**PROPOSED MIXED USE DEVELOPMENT
RESIDENTIAL, AFFORDABLE HOUSING, HOTEL & COMMERCIAL OFFICES
2-4 BURLEIGH ST & 20-24 RAILWAY PDE, BURWOOD**

SSD-77260958

Architectural Response to DPHI Request for Information

This document is prepared in response to DPHI's Request for Information emailed dated 22 December 2025 :

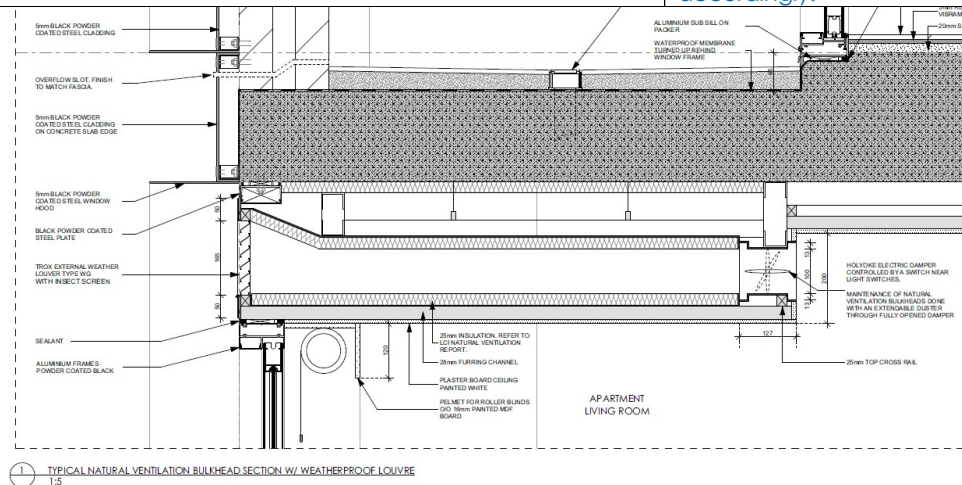
The basement hotel BOH and linen rooms have not been added to GFA calculations/an explanation has not been provided why they should be excluded.

The hotel BOH spaces are intended as storage for the various hotel needs. The hotel linen room is for storage of dirty linen as it is located underneath a linen chute.

The basement hotel BOH and linen rooms are not habitable rooms so are excluded from the GFA calculations according to the Burwood LEP definition.

The B.O.H rooms are now renamed as "Storage" in architectural drawings revision F.
